4052/4054 HARD COPY QUALITY

(FIGURE 1)

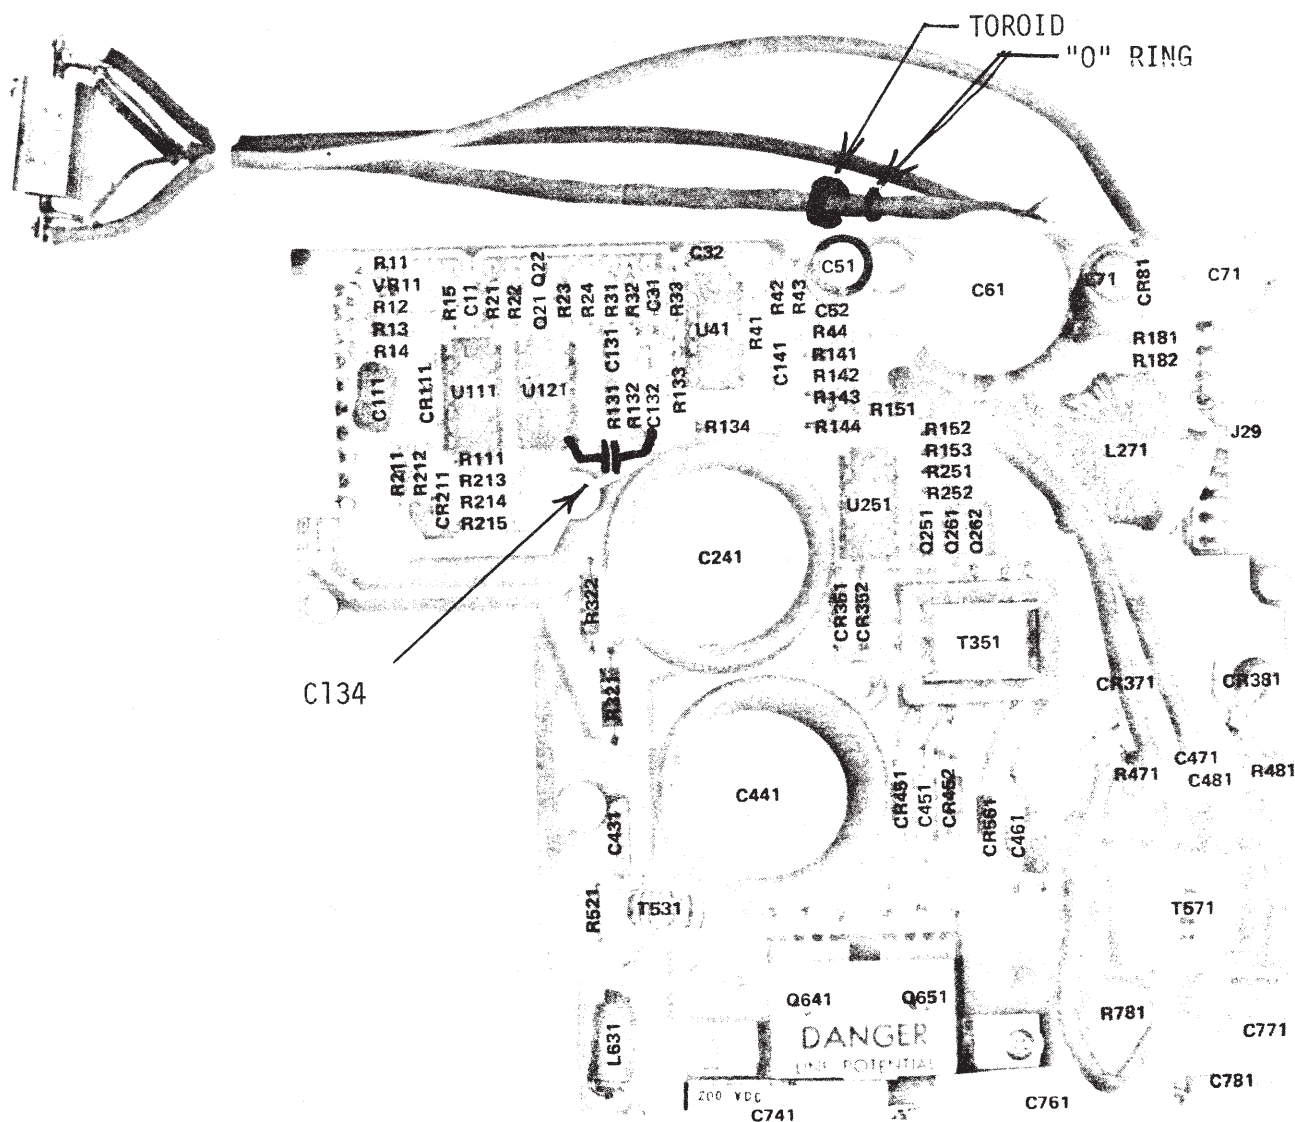
Corporate Mod #39429 adds a capacitor and a toroid to the +5 volt output board. For the 4054 the board level changes from a 670-5622-00 to a 670-5622-01. The board for the 4052 is 672-0833-00. Procedure: (refer to figure 1)

1. Add a 2 μ f CAP C134 P/N 283-0212-00 from the junction of C132, R133, R131 to ground (pin 8 U121)
2. Unsolder the grey cable with the small red and black leads. The red lead attaches to the right side of R134, the black lead attaches to the eyelet under U41. It is important that this be unsoldered at the board, DO NOT UNSOLDER it at the resistor on the back panel.
3. Put the toroid T1003 P/N 276-0640-00 on the gray cable then put an "O" ring 354-0538-00 on the cable to keep the toroid away from the circuit card.
4. Resolder the red and black leads to the circuit card. Red lead to the right side of R134 and the black lead to the eyelet hole under U41.

(FIGURE 2)

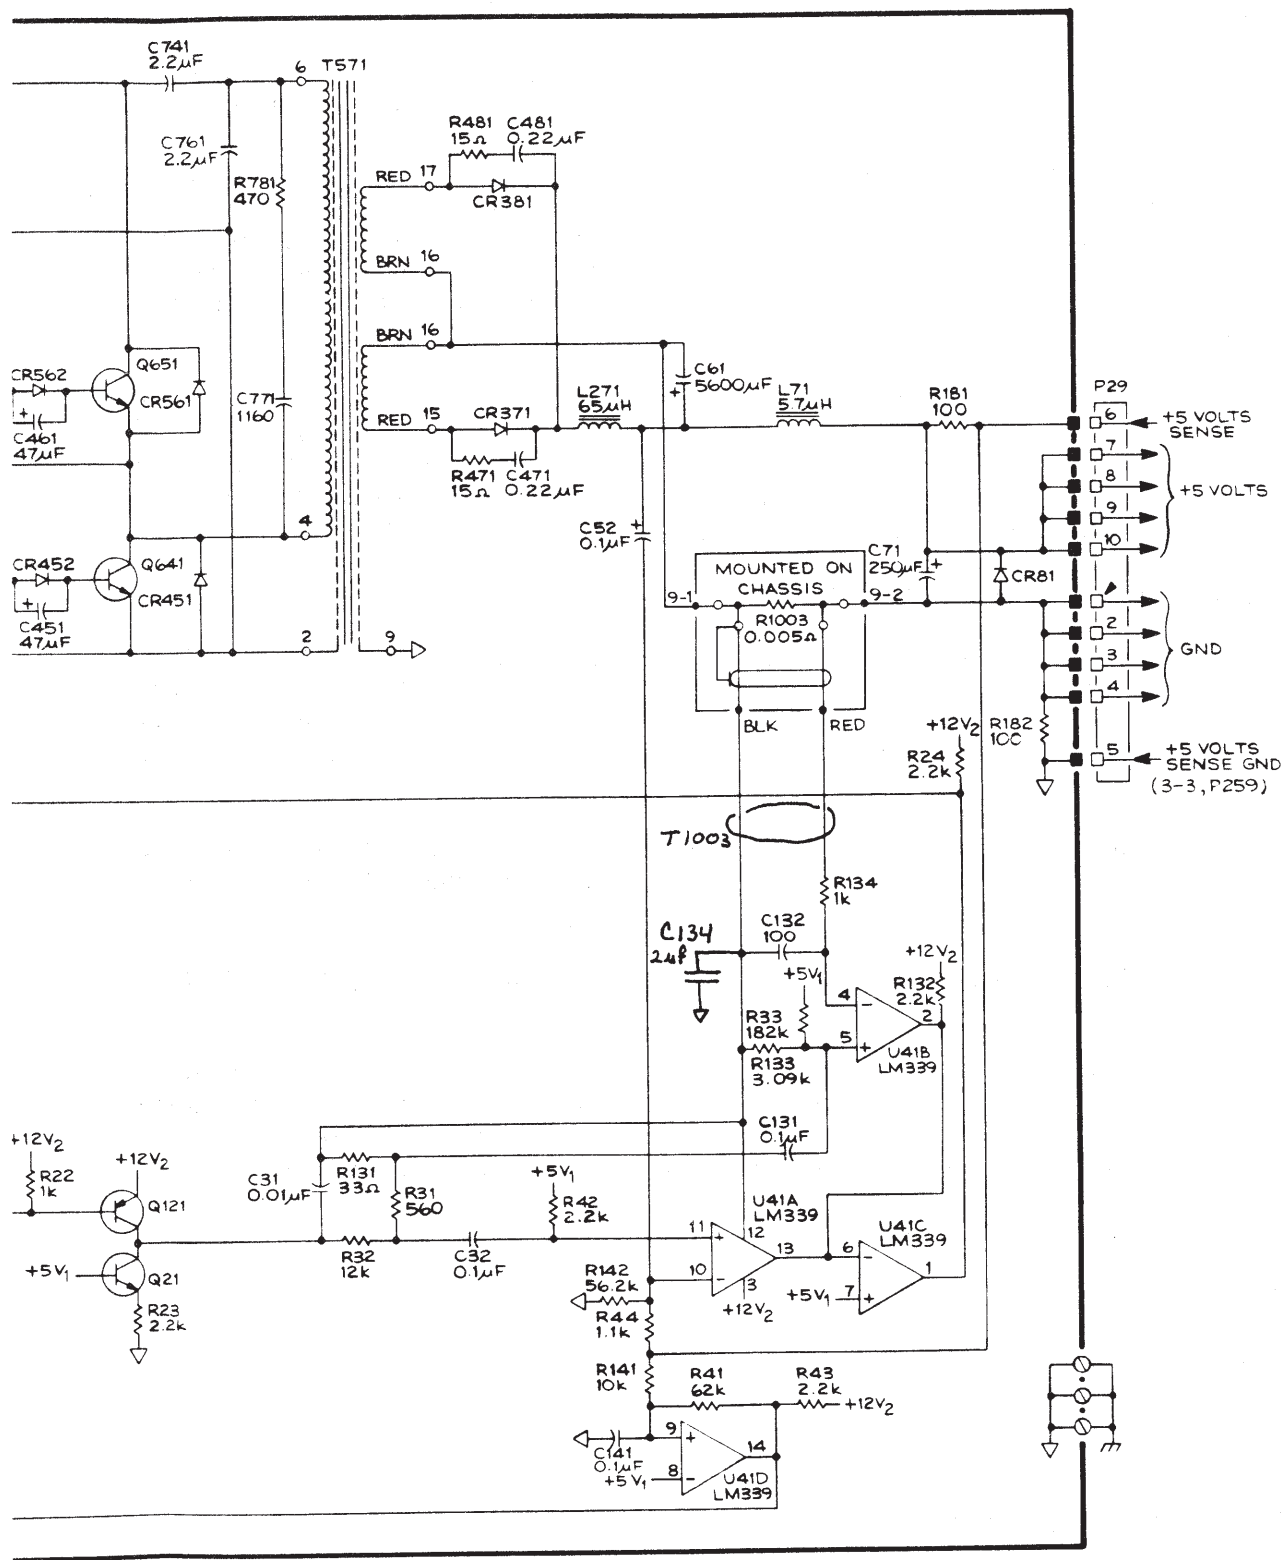
Make the appropriate changes to the schematics and parts lists in the 4052/54 Manuals 070-2829-00 and 070-2839-00 (refer to figure 2).
